**Title:** Crowned Ridge Wind II Sound Testing November 2022  
Data Review and Assessment

**Project:** Crowned Ridge Wind II, Docket EL19-027

**Prepared For:** South Dakota Public Utilities Commission

**Prepared By:** David M. Hessler, P.E., INCE

Figure 2.1.2

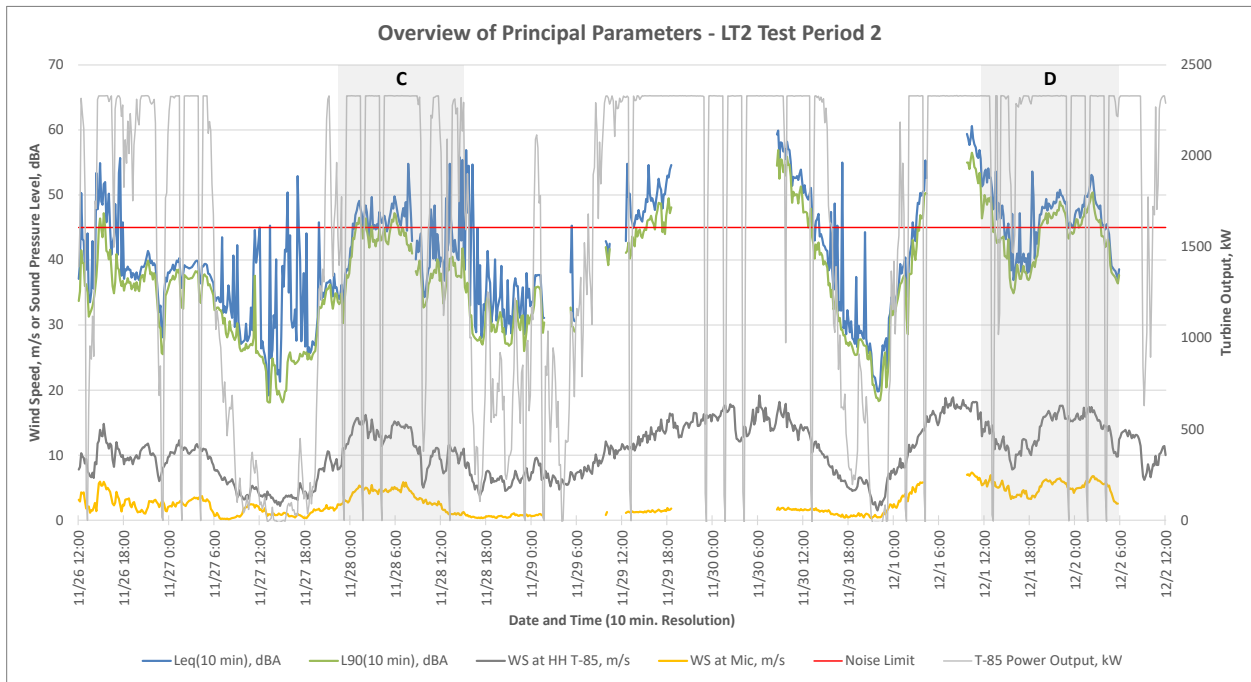
During the second test period (Fig. 2.1.2) it can be seen that the sound measurements are intermittent with a number of missing periods due to some power supply issue. Based on many

years of field survey experience, it can be said that such problems are remarkably common and unsurprising with long-term sound monitoring equipment, especially during cold weather conditions. The validity of the data that are there was checked by plotting the residual (L90) sound levels from all positions together in one graph. These plots, discussed further in connection with LT3, show that the LT2 sound levels are consistent with those recorded a few hundred feet away at LT3. Consequently, the measurements that were recorded appear to be valid despite the technical difficulties.

Figure 2.1.4

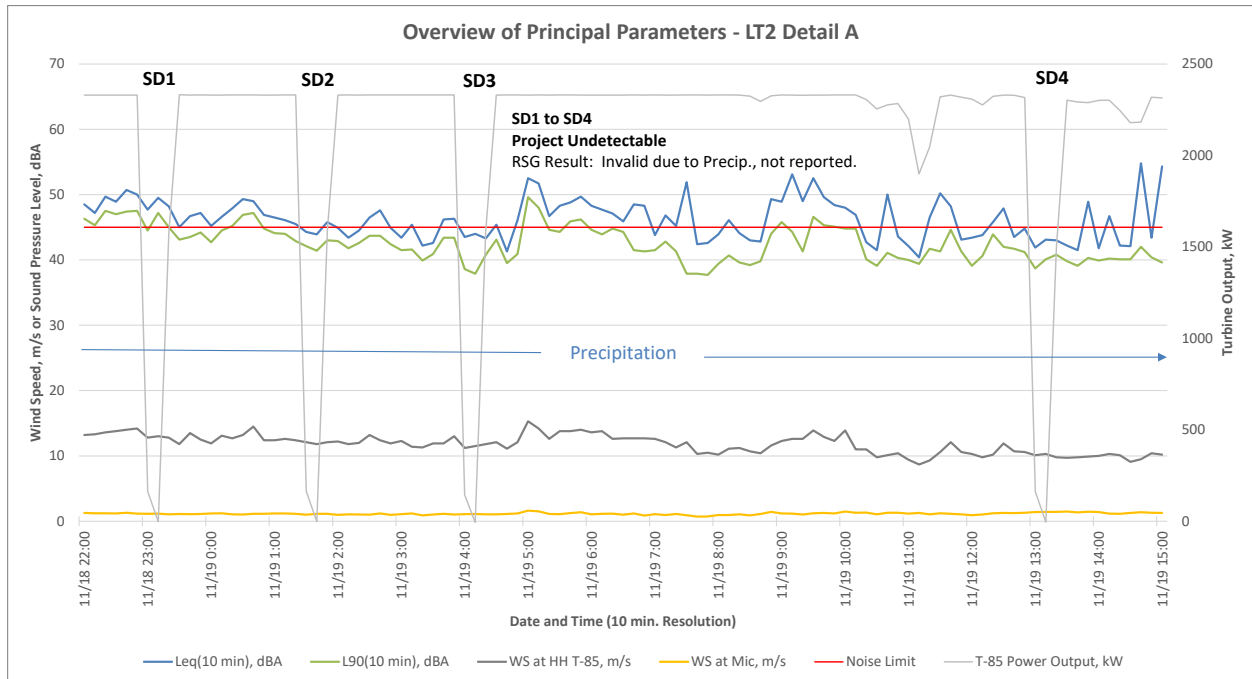
This period is of interest because the project was running consistently at full power while a number of shutdowns occurred, and the sound levels are right at or higher than the 45 dBA limit. Unfortunately, precipitation was occurring throughout this period so no definite conclusions can be drawn from the data. It appears, however, that Project noise was not perceptible above the ambient because both the Leq and L90 sound levels do not drop convincingly during the Project shutdown periods. The slight dip in the L90 during Shutdown 3 could be due to the temporary absence of Project noise or just a random fluctuation.

Figure 2.1.5

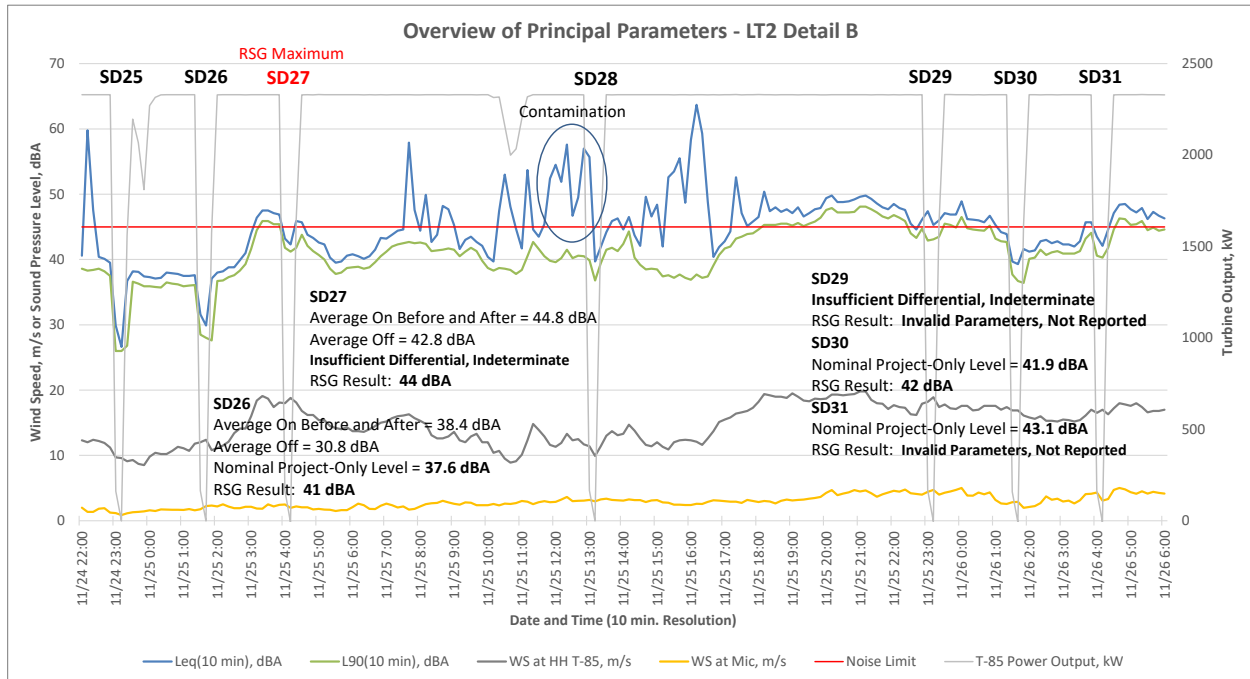
In this case, the effect of the Project shutdowns is much clearer, especially during Shutdowns 25 and 26 when background noise was apparently quite low – and the Project was quite prominent. A definitive project-only sound level cannot be determined for SD25 because Turbine 85 did not cleanly return to full power after the shutdown and the background level just before was contaminated by some noise event. On the other hand, a Project sound level of 38 dBA can be deduced from SD26 by comparing the off sound level to the average on sound levels for the hour before and the hour after the shutdown. RSG is reporting a project-only level of 41 dBA for this shutdown. This higher value comes from using the last (highest) 10 minute period after the shutdown when the background sound level was rapidly rising, rather than the average of the preceding and following hours. Both of these results are well under the 45 dBA limit; however, it is likely that the Project was very audible and “loud” sounding during this period judging from the very substantial difference between the on and off levels. The off level of about 30 dBA is essentially complete silence, so an operational sound level 8 to 10 dBA higher would have been very noticeable from a subjective perspective, while, at the same time, being compliant with the permit noise limit. Such periods of pronounced audibility could be the impetus for the complaints that have occurred, even though the actual Project sound level is fairly low – in this case only around 38 dBA.

The next shutdown, SD27, is important because it is the shutdown resulting in RSG’s maximum, survey high level for this position of 44.2 dBA. This result, as illustrated on p. 49 of the RSG report, was obtained by subtracting mid-frequency (160 to 1kHz) turbine sound occurring in the last 10 minute period (f) prior to the shutdown from the total sound level on a 1/3 octave band

basis as specified in the test protocol. If, looking at it from a less complicated perspective, the project-off level is compared to the hourly average A-weighted levels before and after, the two values (42.8 dBA on and 44.8 dBA off) are too similar to make a valid subtraction. If the average of all 12 before and after 1/3 octave band spectra had been used in the frequency analysis approach a similar indeterminate result may have occurred. Consequently, the individual analysis of select project-on spectra – something not mentioned in the protocol - appears to be a good way of parsing out a result when one might otherwise conclude that no valid differential was observed. In general, this approach tends to yield higher and more conservative Project levels than a simple subtraction of A-weighted on/off levels.

Referring back to Figure 2.1.5, similar results of 41.9 dBA and 42.1 dBA were obtained from SD30 using the simpler A-weighted subtraction method and the frequency analysis method, respectively. For SD31 it is unclear what prevented an RSG result, but we calculate a project-only level at 43.1 dBA.

Figure 2.1.6

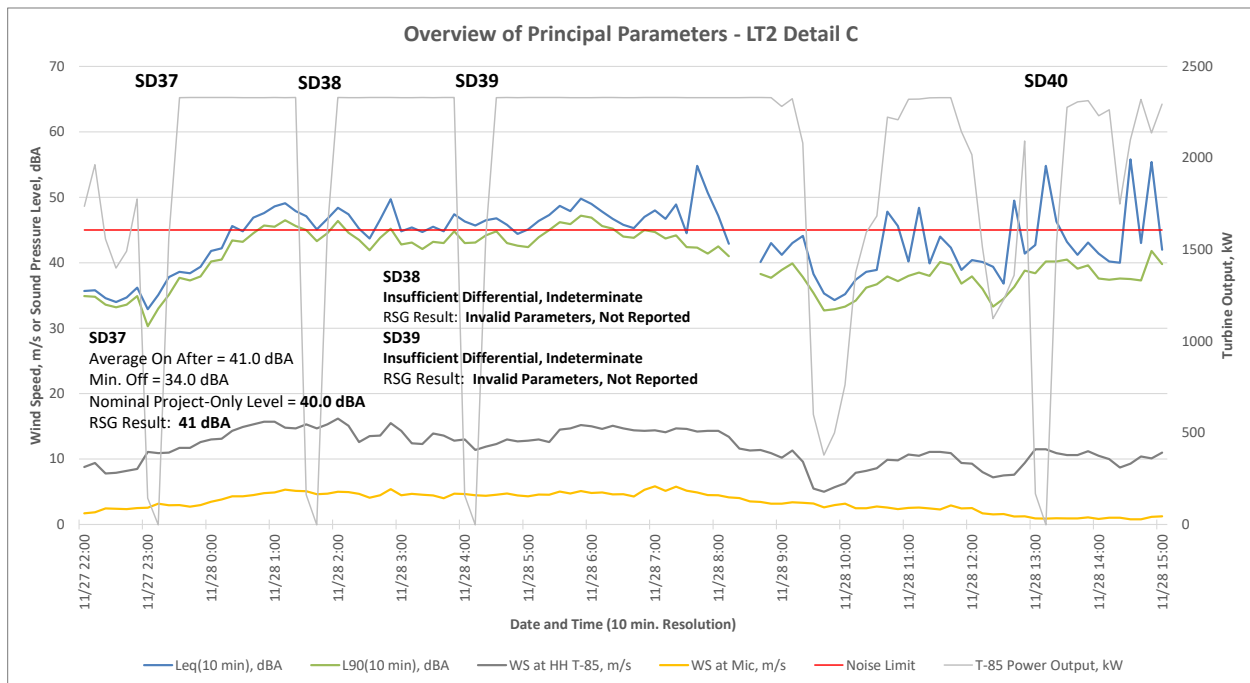
The non-ideal shutdown at 11 p.m. on 11/27 (SD37) still yielded results in 40 to 41 dBA range considering only the project-on sound levels after the shutdown. As the wind speed and background levels increased later that night Project noise became buried in the natural sound level. The on/off levels were too similar to calculate answers for SD38 or SD39. Clearly, there was nothing to be learned from SD40 where the sound level during the shutdown was significantly higher than before or after.

Figure 2.1.7

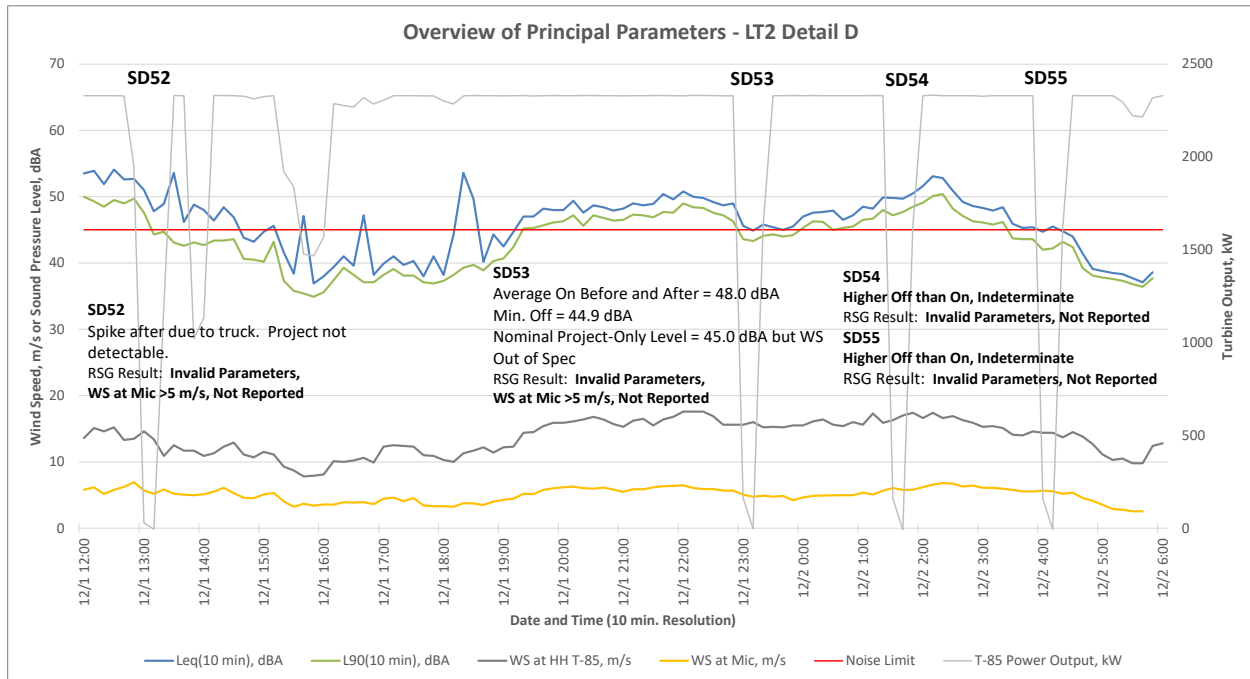
A project-only sound level was not reported by RSG for Shutdown 52 because the ground level windspeed and possibly other parameters, were out of the permissible range. While the dip in the Leq level seems to coincide with the shutdown, the spike immediately afterwards was due to a truck starting up and idling for about 3 minutes before driving off – as determined from a review of the audio files. Moreover, when sound levels drop during a shutdown because Project noise has been removed, both the Leq and L90 levels go down. In this case, the L90 is unaffected by the shutdown confirming that Project noise was not driving the dip in the Leq level. Moreover, the ground level windspeed was above the acceptable limit of 5 m/s in any case.

A somewhat similar situation occurred during the next shutdown (SD53). In this instance, there is a slight dip in both the Leq and L90 sound levels during the outage. While it's technically possible to calculate a Project level of 45 dBA, the ground level windspeed (and the wind-induced background noise associated with it) is again just above 5 m/s so this value is not valid.

Sound levels during the next two shutdowns are clearly unaffected by the absence of Project noise and nothing can be deduced about its sound level. In fact, the sound levels during both shutdowns were higher than when the Project was in operation.

Figure 2.1.8

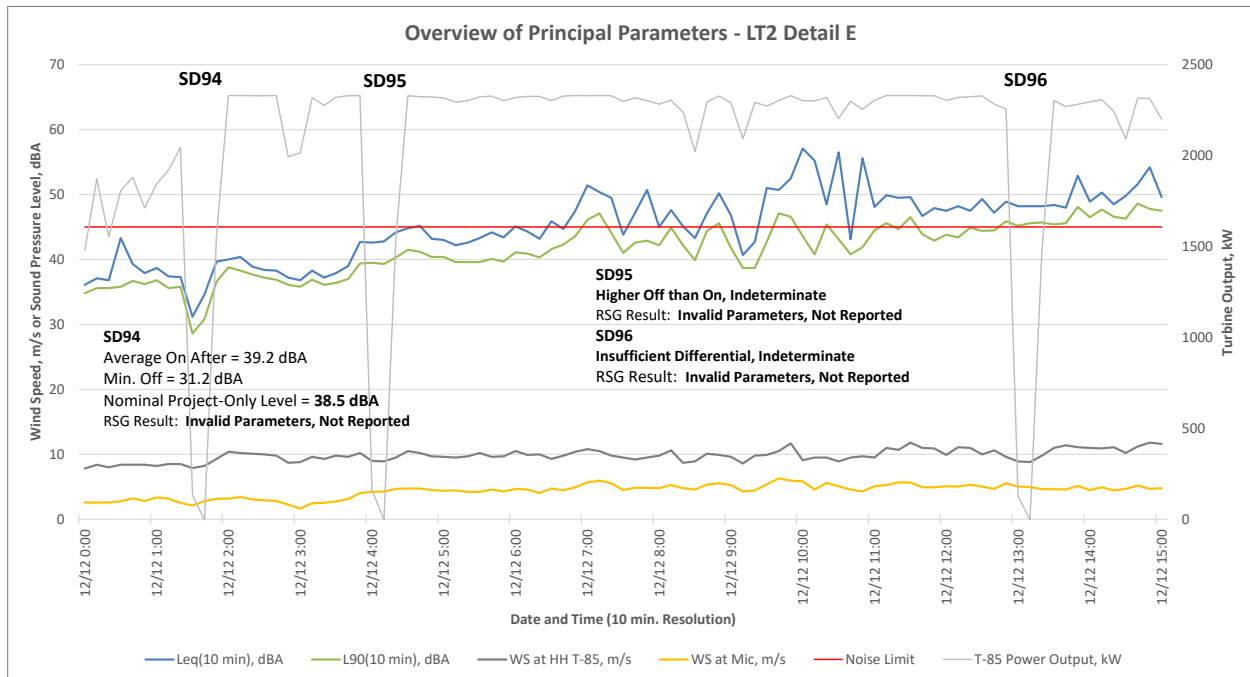
The first shutdown during this period is similar to SD25 and SD26 in Detail B (Fig. 2.1.5) in the sense that the temporary removal of Project noise drops the sound levels significantly. This was another time when the project probably sounded quite prominent relative to a low background level. In absolute terms, however, the Project level can be pegged at a fairly low level of 38.5 dBA using the off and after data. Just two hours later the Project was no longer prominent and is undetectable during SD95, and during the subsequent midday shutdown SD96. Since the wind speeds remained essentially the same through this period, it appears that atmospheric conditions, such as the thermal gradient, may have changed.

Figure 2.2.6

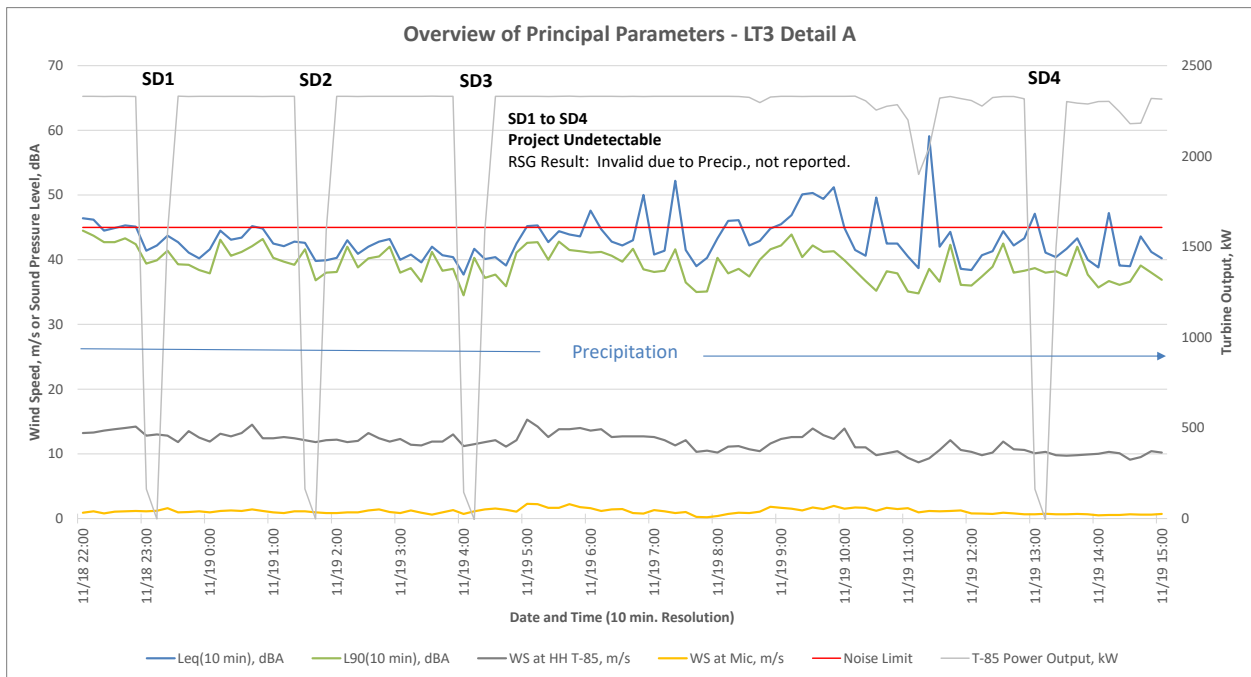
This plot is nearly identical to Detail A at nearby position LT2 (Fig. 2.1.4), the only difference being that the sound levels are generally lower by about 3 or 4 dBA. This may be due to the relative absence of nearby trees at LT3, and the sound of rain falling on the foliage, compared to LT2. In both cases, the Project is undetectable during the shutdowns; i.e. the sound levels don't drop at all.

Figure 2.2.7

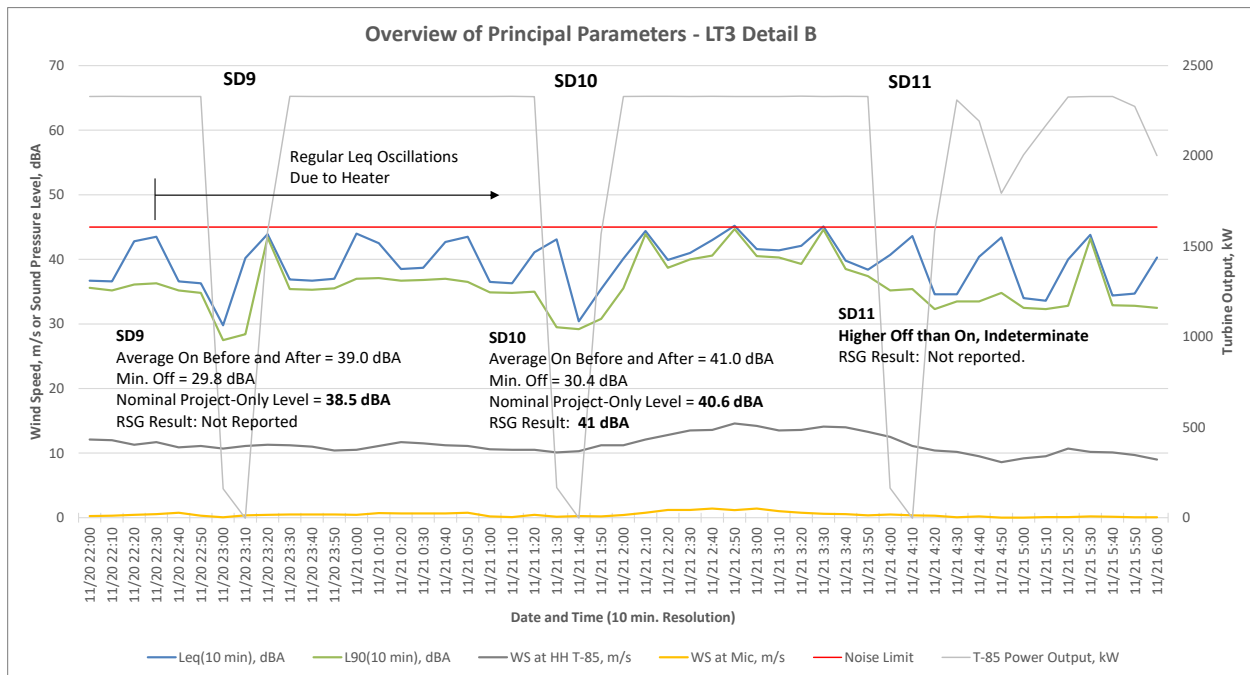
The residual (L90) sound level appears to react to shutdowns 9 and 10 and the Leq level drops to a lower low when the heater was off during those outages. In general, the sound levels from this period cannot be considered valid or accurate due to the ongoing interference. RSG did report a Project level of 41 dBA for SD10, which is what we would calculate as well. Why they did not report SD9 or SD11 is unknown. However, because all of the sound levels are below the permit limit in absolute terms, the actual performance of the Project during this time is moot.

Figure 2.2.8

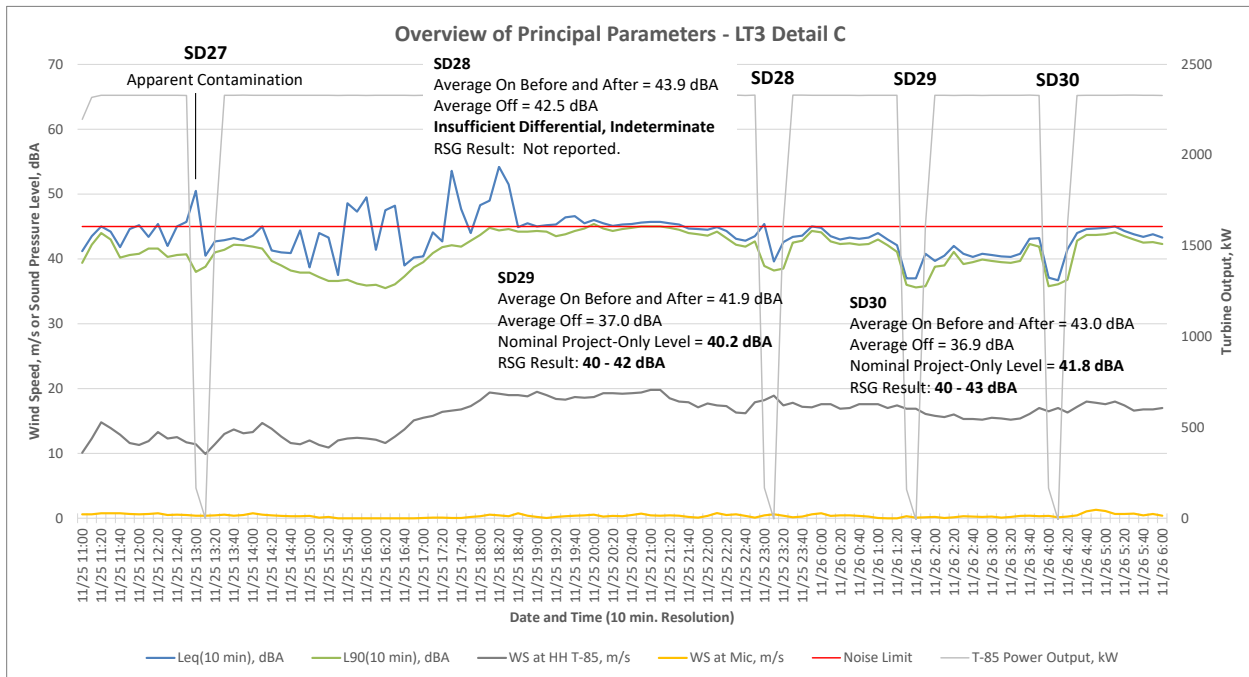
Shutdown 27 was marred by an apparently unrelated noise event, but it can generally be seen that the level would have been below 45 dBA had this interference not occurred. Something similar happened during the next shutdown (a minor contaminating noise event) and it is not possible to derive a project-only sound level. The next two shutdowns, 29 and 30, were clear of any significant contamination and our calculated Project sound levels agree with what RSG reported. All the levels are in the low 40's dBA and in compliance with the permit conditions.

Figure 2.2.9

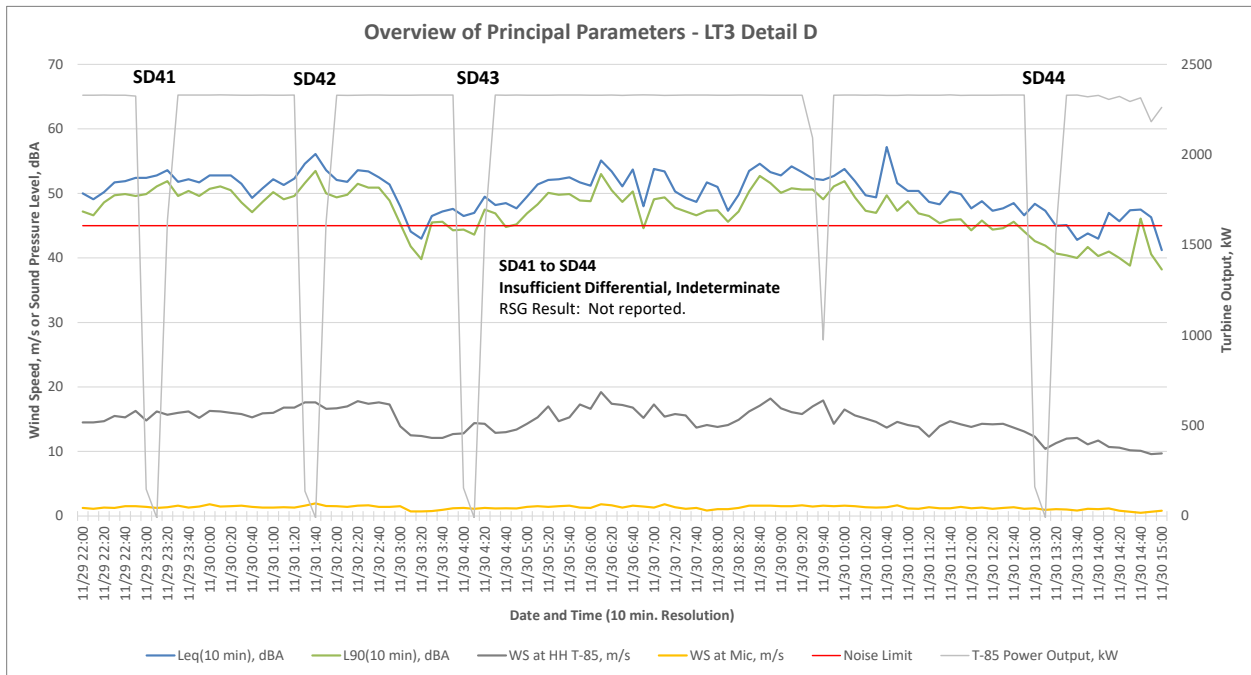
These levels all look good and free from any artificial contamination. The Project was not detectable above the background level during this period and a Project level cannot be deduced from any of the shutdowns.
